**RE: *Item 10.2 – October 20, 2020 City Council Agenda:
C19-013, CP19-013 and T20-015 – Conforming Rezoning, Conditional Use Permit,
and Tentative Map for Certain Real Property Located at 550-570 Meridian Avenue,
1401 Parkmoor Avenue, and 529, 592, and 691 Race Street***

San Jose Vasona Quiet Zone Diagnostic Review Comments & Responses

DATE: August 6, 2019 (Day 1)

DUPONT ST

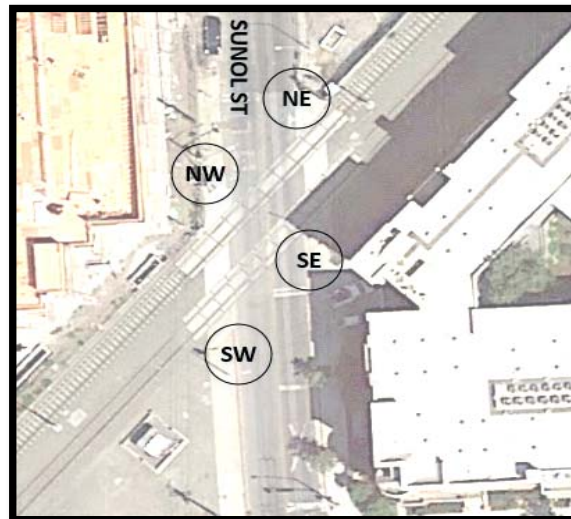
<i>SE quadrant</i>	
6 There is no sidewalk in between the tracks on the south side of the street; this leads pedestrians to enter the roadway in order to cross the tracks; connect the sidewalk over the tracks to keep pedestrians on the sidewalk	City staff and VTA are coordinating to seek developer contributions towards sidewalk and pedestrian treatments as part of the proposed developments on the southwest quadrant of the crossing.
7 The gate is missing bells and missing flashers facing eastbound	See Dupont Comment Response #6. Addition of bells and flashers could be incorporated into the improvements.
8 Signage ineffective – doesn't tell pedestrian what they need to do – there is no channelization	See Dupont Comment Response #6.
<i>NE quadrant</i>

9	There is a staircase connecting Dupont St with the San Carlos St Bridge; there is no sidewalk on the north side of Dupont St, and the staircase offloads pedestrians into the roadway; there is no channelization for pedestrians headed across the tracks; improve	See Dupont Comment Response #6 for planned improvements. In the longer term, the Diridon Station Integrated Concept Plan is a joint planning effort by City of San Jose, VTA, CA High Speed Rail Authority, and Caltrain to redesign Diridon station. On December 3, 2019, San Jose City Council endorsed the plan's recommended spatial layout of the station, which includes elevating the station. The raised station requires removal of the San Carlos Street Bridge and staircase, and a complete redesign of the Dupont Street crossing.
10	There is a chain link fence along the north edge of Dupont St at this quadrant; the fence is obstructing view of the warning signs; remove fence or push it north away from roadway	Caltrain placed the fence there temporarily during a construction project. The fence has been removed.

18	Especially because of the track skew, future development on the private property at this corner should maximize pedestrian line of sight down the tracks to see oncoming trains	City staff will carry this comment through the development review cycle for the proposed development adjacent to the southwest quadrant of the crossing. The latest plan submittal for the development shows the northeast corner of the proposed building setback approximately 35' west from the nearest track and 40' south from the existing face of curb.
19	Visibility – Trees	The existing trees at the northeast corner of the lot adjacent to the rail corridor will be removed by the proposed development. We will also ensure that the development does not place trees or other obstacles near the crossing that would obstruct line of sight down the rail corridor.

SUNOL ST

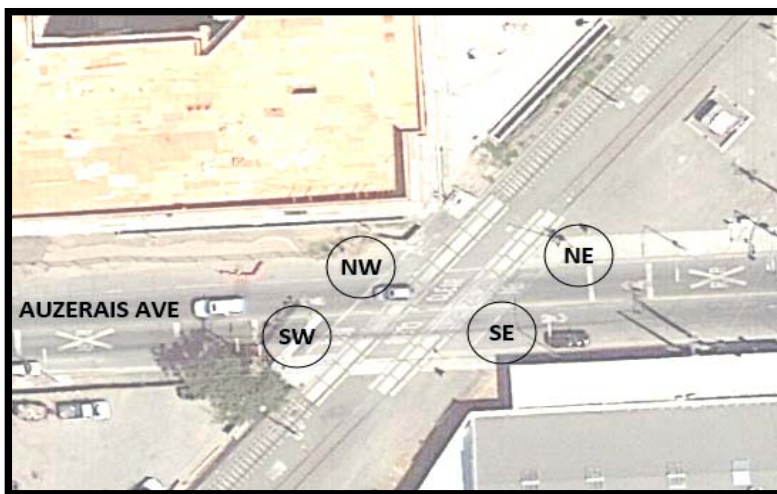
7	NB stop bar doesn't appear compliant; new requirement is a single 24" wide bar	See proposed signage and striping plans in Attachment K. This stop bar will be replaced.
8	There is a driveway that appears to just serve trash collection; this is a bad location just south of the crossing because trash collection vehicles can block traffic's view of the crossing; some vehicles could circumvent the trash collection vehicle and enter the rail crossing when trains are approaching; close this driveway or install a 4-quadrant gate system to mitigate this risk	We reached out to the Monte Vista property management and HOA and offered to close the driveway at no cost to them. They considered it but ultimately decided not to close the driveway because of concerns with using another driveway for trash collection.
9	Remove the two trees on the sidewalk on the east side of Sunol, south of the crossing; these trees block view of the crossing warning devices	The trees in question are juvenile specimens. At maturity, these trees will have a height of over sixty feet and will allow the crown to be maintained at our standard fourteen feet over the roadway to provide adequate clearance for larger vehicles and should not present a long term issue for visibility at the crossing. In the interim, these trees have been raised to between eight and ten feet to provide visibility of the warning signs and devices. This will likely stimulate additional upward growth at the top and allow for a more permanent clearance pruning in 2-3 years.

<i>NE quadrant</i>		
10	Remove "No Left Turn" sign facing northbound traffic since there is no longer a driveway to turn into	See proposed signage and striping plans in Attachment K. This sign will be removed.
11	The slatted fence along the rail corridor blocks views for southbound traffic of trains coming from the north; remove or replace with a fence that doesn't block visibility	Comment for VTA.
12	Remove the nonstandard "No Train Horn" sign that is mounted on the streetlight pole	See proposed signage and striping plans in Attachment K. This sign will be removed.
13	There is an Emergency Vehicle Access driveway within 60 feet of the crossing; this is problematic because vehicles using this driveway can cause downstream traffic to queue over the tracks	See Attachment L for proposed gates. A 4-quadrant gate system is proposed.
<i>NW quadrant</i>		
14	Replace defective gate arm (immediate action item unrelated to quiet diagnostic meeting)	VTA replaced the defective gate arm immediately after the diagnostic meeting.

15	Missing required warning signage and pavement markings; install immediately	RXR pavement marking has since been installed. A missing W48(CA) sign will be installed (Attachment K).
16	There is no ADA path to the crossing- create an ADA path approaching and into the crossing	See Attachment L for proposed gates. Pedestrian treatments, including expanded sidewalk, are proposed.
17	What type of wall is the developer installing along the rail corridor? It should allow visibility of the rail corridor	The developer installed a chain link fence; it allows for visibility between the sidewalks and rail corridor
18	Is the lower traffic signal head mounted at a compliant height? Appears very low	We reviewed all locations where there is a pole-mounted traffic signal head at a low height over the sidewalk (Sunol, Race, Parkmoor, Fruitdale, Leigh, Stokes). These supplemental signal faces provide extra visibility for drivers of the pre-signal indication. After the striping and signage plans and other planned improvements are implemented, we will evaluate whether these signal heads still provide a benefit or should be removed.

AUZERAIS AVE

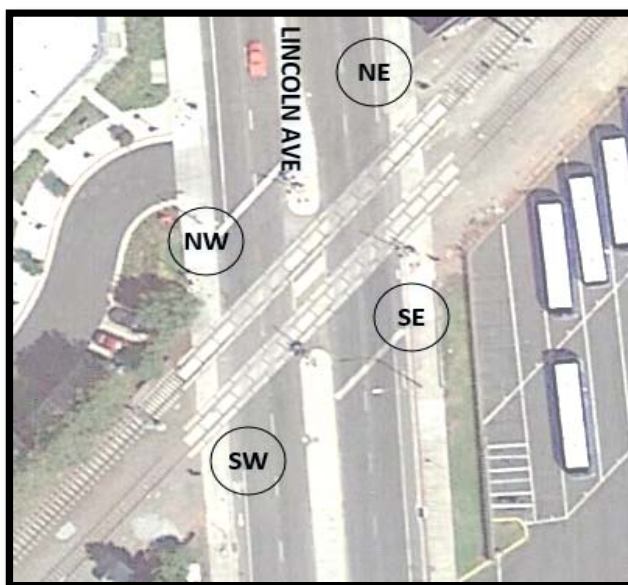
8	Fence off all sides of the triangular parcel at the northwest corner of the Auzerais/Sunol intersection to prevent trespassing onto the rail corridor and to help channelize pedestrians to the pedestrian crossings	The adjacent developer is preparing a proposal for improving this triangular parcel. We asked the developer to include channelization elements that deter trespassing.
---	--	--

9	There is a gate arm for a driveway that used to exist but was removed with the new development; the driveway gate extended into the roadway as well, functioning as a quasi-exit gate the developer wanted to remove the gate arm, and met with CPUC and VTA; CPUC wanted the developer to install pedestrian treatments as part of the work; the developer disappeared; City and VTA are coordinating on comprehensive improvements at this crossing as part of VTA's Pedestrian Back Gates project	A GO88b was issued to CPUC and CPUC provided approval to remove the gate arm. VTA has a contractor on board who is working on the programming that needs to be adjusted before the obsolete gate arm can be removed.
---	--	--

10	VTA recently determined that this third gate arm is a pedestrian collision hazard; the gate comes down 7 seconds after the other gates (to allow westbound vehicles to clear the crossing; with the new sidewalk installed, eastbound pedestrians are channelized towards this quadrant and could enter the crossing and get trapped on the tracks by the lowered gate; VTA and the developer have installed barricades on the sidewalk to deter pedestrians from crossing here; City and VTA are coordinating on a GO88 to remove the remnant gate arm in the near-term and re-open the sidewalk	See Auzerais Comment Response #9.
----	---	-----------------------------------

11	Replace W10-9P with the standard size consistent with your other locations	See proposed signage and striping plans in Attachment K. This sign will be replaced.
12	There is a tree on the private property side of the fence which is blocking visibility of the crossing warning devices and appears to be in contact with overhead electrical lines; remove this tree or trim it down substantially	This tree will be removed.
13	Remove "Road Construction Ahead" sign mounted on the PG&E pole if it is no longer needed	See proposed signage and striping plans in Attachment K. This sign will be removed.
14	The private property adjacent to this quadrant has a driveway cut; this driveway is too close to the crossing; close the driveway and replace with sidewalk and curb	The owner has agreed to let the City close the two existing driveways on the southwest quadrant of the crossing and install one new driveway at the west edge of the property approximately 120 feet away from the gate arm. See Attachment K.

LINCOLN AVE

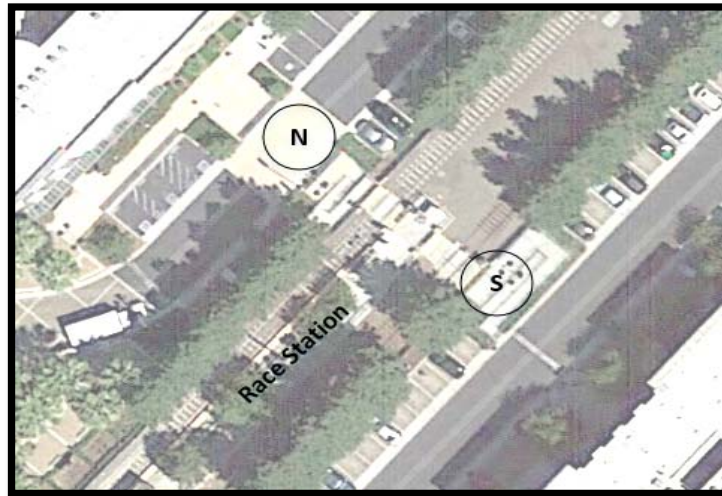
<p>5 A 4-quadrant gate system would be ideal here because of the cars driving at higher speeds, because of the adjacent driveways on both north quadrants, and because of the adjacent alcoholic establishment</p>	See Lincoln Comment Response #4.
<p>6 Pedestrian gates not prioritized at this location as it does not appear to have high pedestrian flows</p>	n/a - informational comment
<p>7 While diagnostic review was being conducted, a bicyclist ignored warning devices signaling a train was coming and went through the crossing as arm gates were coming down</p>	n/a - informational comment
<i>SE quadrant</i>	
<p>8 change W10-9P sign to our current standard</p>	<p>See proposed signage and striping plans in Attachment K. This sign will be replaced.</p>
<p>9 relocate bus stop and bus stop sign</p>	<p>VTA removed this bus line in December 2019 as part of a new transit service place.</p>

10	gate on sidewalk is missing flashers facing north	Comment for VTA.
11	the gate in the sidewalk and the warning signs crowd the sidewalk and could lead to pedestrians walking behind the sidewalk around the control devices; suggest relocating warning signs and adding pedestrian channelization	See proposed signage and striping plans in Attachment K. The R15-8 sign will be removed.
12	warning signs look big; check dimensions	See proposed signage and striping plans in Attachment K. The R15-8 sign will be removed. The W82-1(CA) and W10-9P signs conform to CA MUTCD size requirements.
<i>NE quadrant</i>		
13	the adjacent plaza has 3 driveways on Lincoln and one driveway on Auzerais; the driveway just north of the crossing is located very close to the tracks and raises the risk of a vehicle driving in opposing traffic across the tracks; also, the establishment in the plaza that is closest to the tracks is an alcoholic establishment; close this driveway if possible	See Lincoln Comment Response #3.

14	if the driveway cannot be closed, add a median mounted "Right Turn Only" sign, stripe the driveway as a right turn out only, add edge lines in the driveway to guide vehicles to turn right out, and modify the driveway to physically force vehicles to turn right as they exit	If the driveway cannot be closed, City will request that it be marked right-out, exit-only, and City will evaluate locating a "Right Turn Only" sign in the median.
<i>NW quadrant</i>		
15	check W10-9P sign for consistency	See proposed signage and striping plans in Attachment K. This sign will be replaced.
16	the residential development should not have been allowed to locate the driveway within proximity of the tracks	See General Comment Response #14.
17	check ADA compliance around gates	This crossing in general was not considered to have high pedestrian volumes and thus was not prioritized for pedestrian treatments.
18	widen the sidewalk to the back to open up an ADA path for pedestrians around the gate	See Lincoln Comment Response #17.

19	the tree right next to the gate is overgrown and blocking visibility of the warning devices; remove it or trim it back considerably and maintain regularly	The City will trim this tree, or follow up with the property management for tree trimming.
20	warning signs look big; check dimensions	See proposed signage and striping plans in Attachment K. The R15-8 sign will be removed. The W82-1(CA) and W10-9P signs conform to CA MUTCD size requirements.
21	gate is missing flashers facing south	Comment for VTA.
<i>SW quadrant</i>		
22	the visibility between this quadrant and the rail corridor is limited because of the tracks skew and trees lining the rail corridor; flashers and bells are needed at this quadrant	Comment for VTA. VTA is considering pedestrian treatments here as part of their Pedestrian Back Gates project.

RACE STATION

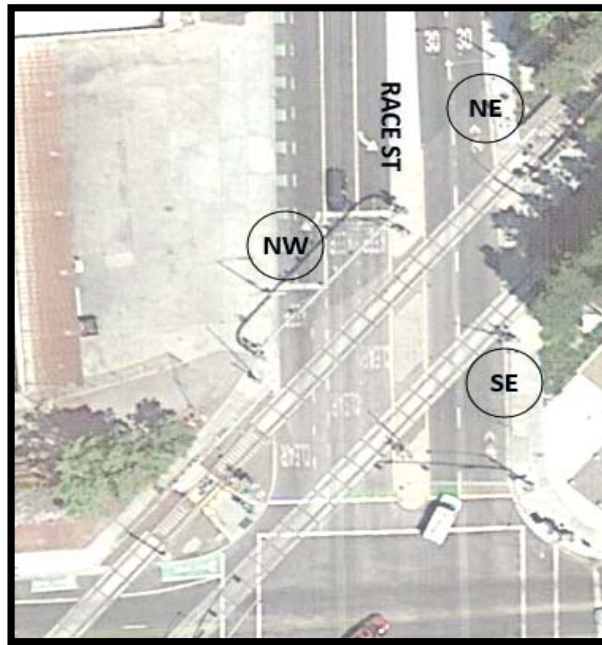
Comments	Response
<i>General</i>	
1 Crash History 2007 - 2019: none	n/a - informational comment
2 Land Uses: high density residential both sides	n/a - informational comment
3 Detectable warning strips should be outside of the gates; currently they are inside the gates which can give the wrong impression to a vision-impaired user that they are within a "safe zone"	Comment for VTA.
4 The north side of the crossing doesn't have flashers positioned in advance of the gates; Install Commission Standard #8 flasher	Comment for VTA.

RACE ST

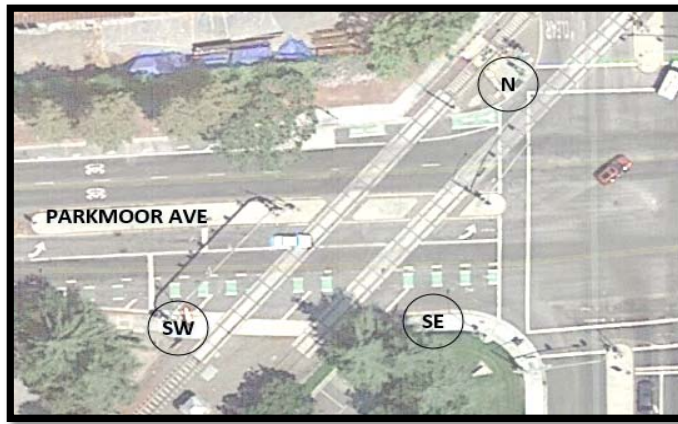
8	<p>FRA is concerned with these two crossings (Race & Parkmoor); track and intersection geometry is very challenging to mitigate; multiple collisions, especially at the northwest corner of the Race/Parkmoor intersection; existing school on the southeast corner of the intersection; and now a school going to open on the northwest corner of the intersection. This would be an ideal candidate for grade-separation of the light rail track (e.g. see LRT flyover at Hamilton Ave in San Jose).</p>	<p>The City developed a new plan line for Race St and Parkmoor Ave to improve this location. See Attachment L.</p>
9	<p>Per CPUC, this location would be an ideal candidate for a pedestrian overcrossing.</p>	<p>A pedestrian overcrossing is not preferred because it would require pedestrians to take a longer and less direct path and, is not expected to achieve high compliance at this location. Instead, this crossing will be reconstructed to improve safety for all users at-grade. See Attachment L.</p>

10	<p>FRA prepared a concept for a redesign of the intersection and crossings that they would like to share with the group</p>	<p>City obtained the concept from FRA. The concept relocates the north leg and west leg crosswalks to the north and west sides of the tracks, respectively. This was one of two concepts that City staff evaluated. City staff determined that in order for the crosswalks to operate safely and be protected from right-turning drivers, they would need to be signalized and have an exclusive pedestrian phase coinciding with an all-red for the rest of the intersection. City staff determined that this would yield an unacceptable impact on operations, noting that the signal already experiences all-red over 160 times per day with each LRT movement through the intersection. This type of impact would be expected to result in driver frustration and violations of the signals, which would put pedestrians at more risk. Instead, this crossing will be reconstructed per the concept in Attachment L.</p>

14	<p>Median dividing northwest and northeast quadrants does not meet curb height requirements</p>	<p>The City of San Jose will add channelizers onto the median islands in the near term. In the long term, the median islands will be reconstructed to a minimum 8" height as part of the proposed development on the northwest corner of Race/Parkmoor.</p>

15	Gate does not meet current MUTCD standard clearance required between the center of the pole and the face of curb	See Attachment L. This gate arm would likely be replaced.
----	--	---

16	The proposed development should not be allowed to have any driveways within 100 feet of the crossing	See Race Comment Response #4.
----	--	-------------------------------

17	Southbound vehicles on Race often miss the stop bar for the pre-signal; need to refresh pavement markings; check if signage, pavement markings, etc. can be modified to yield higher driver compliance. Possible candidate to install crosshatch pavement markings.	See proposed signage and striping plans in Attachment K. In the near-term, the stop bar will be relocated and signal heads will be evaluated.
----	---	---

PARKMOOR PEDESTRIAN

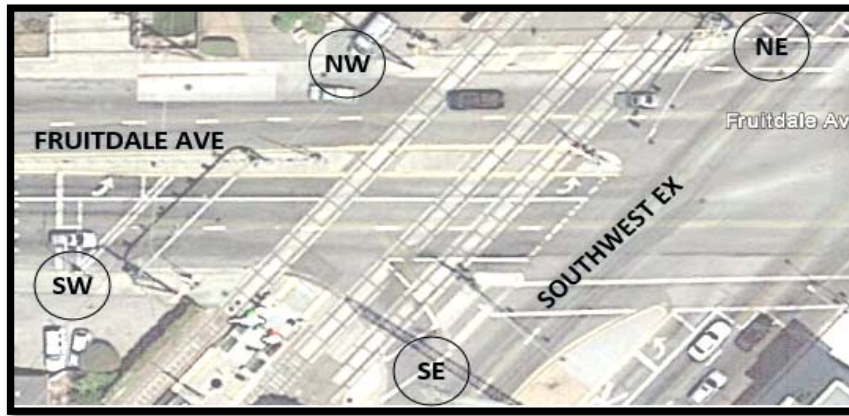
Comments	Response
<i>General</i>	
1 Crash History 2007 - 2019: none	n/a - informational comment
2 Land Uses: office building to the north and associated parking lot to the south	n/a - informational comment
3 Current swing gates are chain link and camouflage with the fence; convert to VTA standard swing gate	Comment for VTA.
4 There are multiple surfaces across the tracks (asphalt, ballast, concrete); repave to make one, consistent smooth surface (e.g. see Fruitdale Station); refresh paint for edge lines that line the crossing over the tracks	Comment for VTA.

FRUITDALE AVE

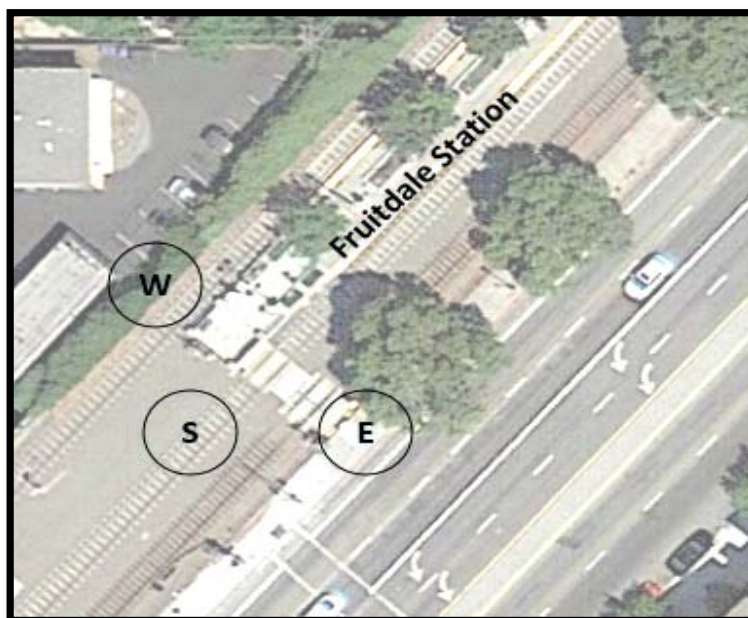
<p>7 While diagnostic review was being conducted a truck and 2 cars became stuck between activated arm gates and intersection at both the Southeast and Northeast quadrants indicating the timing of the signals needs to be adjusted to allow vehicles to adequately clear the area</p>	<p>Track Clearance timing doesn't start after the gates are down, but before that, in order to let the vehicle to pass and clear the intersection. During the diagnostic review at this intersection, the timing settings for preemption events were checked and were found to be adequate. The preemption log was shown to FRA and CPUC representatives.</p>
<p>8 While diagnostic review was occurring, members of the team became caught between the light and the gate arm at the northwest and northeast quadrants indicating the timing of the signals needs to be adjusted to allow pedestrians to clear the area</p>	<p>Also, see proposed signage and striping plans in Attachment K. For the eastbound movement, the pre-signal stop bar will be relocated, the downstream stop bar eliminated, and Keep Clear pavement markings added at the tracks. These striping changes should reduce the amount of eastbound drivers crossing the tracks after the pre-signal turns red and track clearance is underway.</p>

<p><i>SE quadrant</i></p>	<p>The crossing across the rail tracks is not signalized, therefore the pedestrian crosswalk timing on the north leg of the intersection does not include time to cross the tracks. We acknowledge that the pedestrian storage space at this corner between the gate arm and the curb is limited. Further, there is no crosswalk on the west leg of the signalized intersection. To accommodate pedestrian movements across Fruitdale, DOT will install a new crosswalk on Fruitdale Ave, approximately 460 feet west of the tracks. This will serve pedestrians between the residential neighborhoods to the north and the LRT station to the south. By using this crosswalk, most pedestrians will not need to travel through the northwest corner of the signalized intersection where the storage space is limited.</p>
<p>9 EB Fruitdale drivers tend to violate the pre-signal; adjust the louvers on the far-side traffic signal heads so that upstream drivers don't see the green light until they pass the pre-signal</p>	<p>See proposed signage and striping plans in Attachment K. The stop bar will be relocated and signal heads will be evaluated.</p>

<p>10 Check track clearance green time for EB Fruitdale is set correctly in traffic signal controller</p>	<p>See Fruitdale Comment Response #7.</p>
<p>11 refresh paint for edge lines that line the crossing over the tracks</p>	<p>Comment for VTA.</p>
<p>12 Fruitdale EB right is high speed and has low visibility with pedestrians at the corner or pork chop; crosswalk between the corner and the pork chop is also problematic because it leads pedestrians into the tracks without any other protection or warning devices besides a detectable warning strip; suggest reconfiguring the geometry, e.g. bring the curb out into the roadway to expand the ped refuge on the sidewalk, cut the pork chop island back, and add full pedestrian treatments with Commission Standard 9 pedestrian gates, EXIT swing gates, and channelization on the sidewalk</p>	<p>See proposed signage and striping plans in Attachment K. Eastbound right turn edge line striping will be shifted to narrow the lane, slowing down traffic, and making the vehicle lane meet the crosswalk closer to a 90-degree angle rather than a sweeping curve. Raised pavement markers are added on the edge striping to emphasize this effect. The existing No Turn On Red sign at the pre-signal is replaced with the graphical equivalent, R13A (CA). The placement of the Stop Here on Red sign is corrected to be below the R13A (CA) instead of above.</p>

13	There is a streetlight in the sidewalk that is blocked by the tree	Trees have been trimmed.
<i>NE quadrant</i>		
14	W10-4 is blocked by trees; trim trees	Trees have been trimmed.
15	Pedestrian refuge in the sidewalk is extremely small; very little space for even one person to wait while gate is down	See Fruitdale Comment Response #8.
16	Refresh pavement striping	See proposed signage and striping plans in Attachment K.
17	Southbound right turn queue backs up in the peak and drivers often violate the "No Right Turn" sign which is activated with the crossing devices	There is a vehicle gate arm and median island that prevent drivers from circumventing the gate arm.
<i>NW quadrant</i>		
18	Driveway closest to the crossing should be striped as a right turn out only; add edge lines in the driveway to guide vehicles to turn right out, and physically modify the driveway to force vehicles to turn right as they exit	See proposed signage and striping plans in Attachment K. A Right Turn Only sign for the westerly driveway will be added. The westerly driveway cannot be physically modified to force a right turn out because it is also used as an entrance driveway for vehicles turning right in.

19	This pedestrian gate is an old design; if upgraded, the new design should include a swing gate next to the automatic gate and channelization	n/a - informational comment
20	Warning signs are located very close to the sidewalk, partially obstruct sidewalk path	See proposed signage and striping plans in Attachment K. The R15-8 sign will be removed.
<i>SW quadrant</i>		
21	Change "No Train Horn" sign located under the W10-1 to standard dimension	See proposed signage and striping plans in Attachment K. This sign will be replaced.
22	Refresh pavement markings on EB Fruitdale	See proposed signage and striping plans in Attachment K.
23	"No Train Horn" and "Look Both Ways" warning signs mounted on sound wall are covered by ivy; relocate to pole mount	See proposed signage and striping plans in Attachment K. These signs will be relocated.
